**Item 3:** 07/21/0519/F

**Location:** Homebase Ltd, Sturlas Way, Waltham Cross

**Description:** Refurbishment, extension and external alterations to existing non-food retail unit to enable it to trade as part foodstore and part non-food retail unit, alongside modifications to existing external garden centre, car parking layout, landscaping and other associated site works.

**RECOMMENDED that planning permission be refused for the reasons set out at the end of this report**

*Proposed site plan*

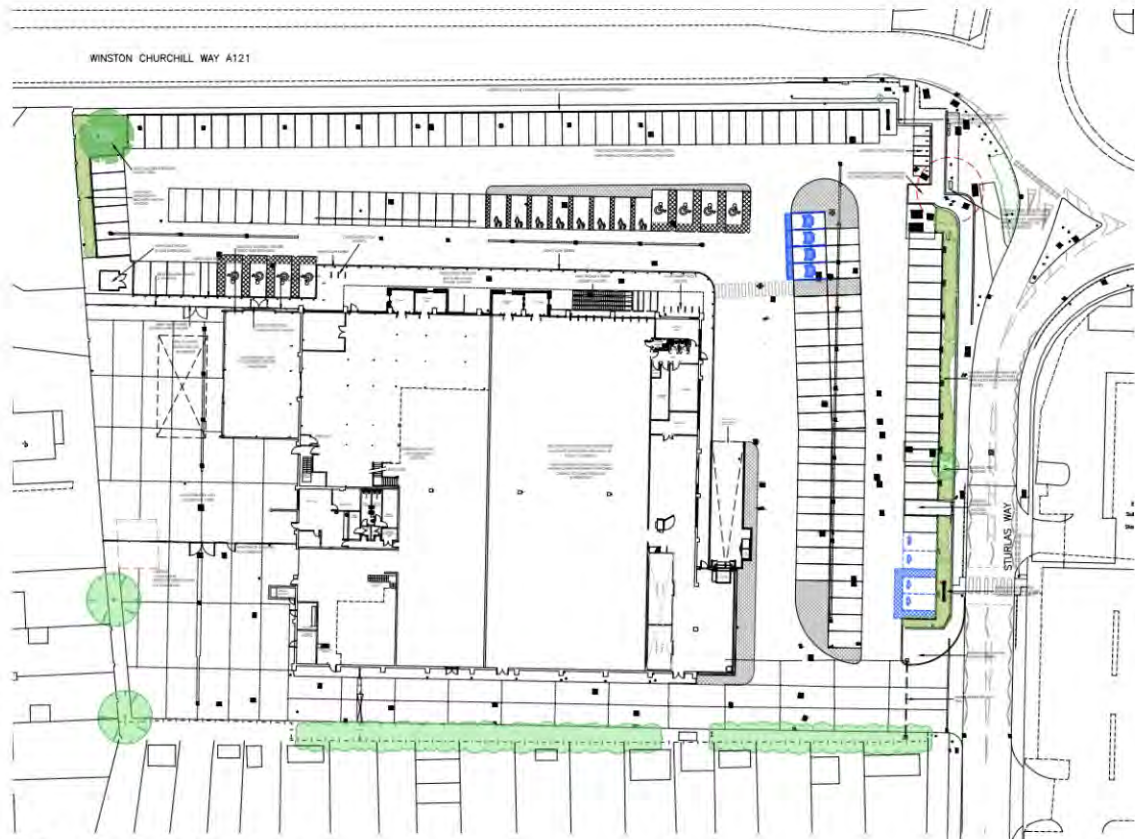
- 8.11 In terms of the layout, the building would remain in its current position within the site. The existing customer entrance is located to the eastern elevation. The proposal would remove that arrangement so that two entrances for the stores would be located to the north elevation with glazed extensions projecting 3m to the north with a width of 8.6m and height of 4m. A new extension would be located to the east elevation measuring approximately 16m in length, 6.1m in width and a height of 7m with an acoustic barrier extending a further 1.4m in height. A ramp measuring 19m in length with a width of 5m would be excavated sloping down towards the extension that would provide the service area and loading bay requirements for the Aldi store. The supporting text to Local Plan Policy WC2 sets out that this northern end of the High Street 'turns it back' on the street and creates closure to the pedestrian core, consequently limiting footfall. This proposal is not considered to improve that issue, quite the contrary. It would rather create further isolation from the active site frontage, given that the entrances would face away from the pedestrian route to the site from Sturlas Way.

- 8.15 The layout of the car parking has been amended. The vehicular access remains in its current position to the south west corner of the site and car parking occupies the northern and eastern parts of the site as existing. There would be a reduction in the car parking capacity due to the position of the proposed new extension for the Aldi service area to the east and rearrangement to the north where part of the garden sales area is to be removed and replaced with new entrances, trolley and cycle spaces. The matter of parking is considered in the following section. The vehicular routing around the site appears logical and there is sufficient space to manoeuvre in and out of the car parking spaces. However, the position of the proposed new service area would present some conflict between delivery lorries and customer vehicles entering and leaving the site. Whilst this would depend on the delivery times and whether these coincide with store opening times, this matter adds to the concerns raised above with regards to the location of this service area in a prominent position and directly adjacent to customer activity rather than in a more inconspicuous location as existing to the rear of the building.

- 8.21 The submission indicates that there would be a pedestrian link from the store entrances across the car park to Sturlas Way which then has its own links to the town centre. However, this is not reflected in the plans. A pedestrian link only partially crosses the site and it is not clearly marked out. The Highway Authority also state that a walking and cycling survey should have been provided that would set out recommendations to improve the safety of pedestrians and cyclists between the site and the town centre and Winston

*Proposed east elevation*

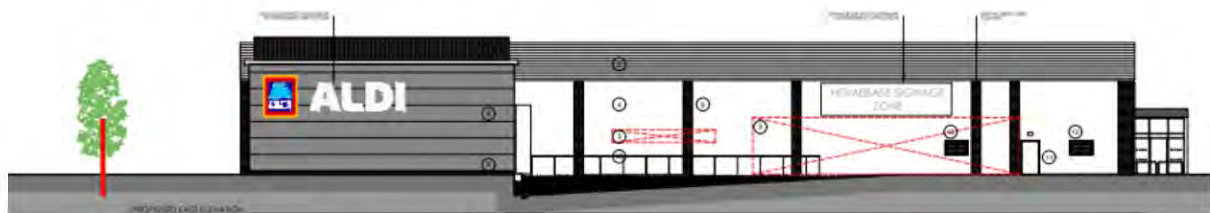
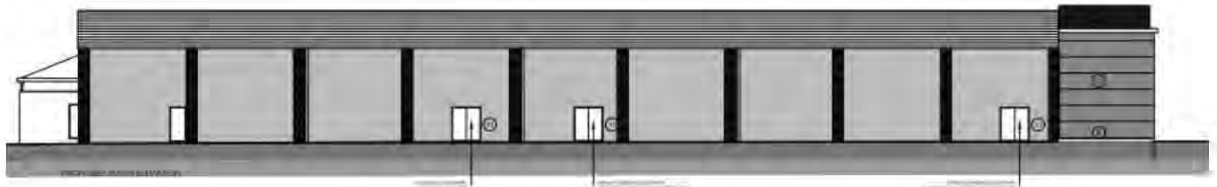
- 8.12 Being presented with the service area of the store to the east with its associated ramp and loading bay exposed to the wider area is also considered to be an inappropriate arrangement as it would not be an attractive public fronted elevation. The submission states that the service area for Aldi is located to the south east of the store to '*ensure it does not detract from any key views from Winston Churchill Way*' and the customer service entrances would '*provide a strong presence and frontage to Winston Churchill Way*'. The submission continues by stating that the arrangement is particularly important given the site's gateway location into the town centre from the north taking note of the sites active frontage. However, Winston Churchill Way is screened by a high boundary wall, as seen in the report photos, therefore the north elevation is not directly visible on approach to the town centre. The sites main elevation that has a more pronounced public view and active frontage is the north eastern corner and the east elevation from Sturlas Way. This elevation is given little

- 8.14 The proposal would provide façade alterations to the building to integrate the extension to the east elevation and infill the façade where the section of the building to the north would be demolished. The overall height of the building would remain as existing. The alterations would include repainting of the existing high level cladding in anthracite grey, provision of acoustic screening on the roof, new and existing infill blockwork to be finished in white render, the eastern extension to be finished in flat composite cladding panels finished in metallic silver, anthracite grey cladding and black lower level brickwork, existing brick piers would be retained and cleaned, new glazed shopfronts, windows entrance doors, fascias and rainwater goods would be finished in anthracite grey powder coated aluminium. These façade amendments are considered appropriate improvements that would modernise the appearance of the existing building. However, these are not as beneficial as a high density, mixed use redevelopment sought within the local plan policy allocation that would enhance this gateway site and promote the town centre.
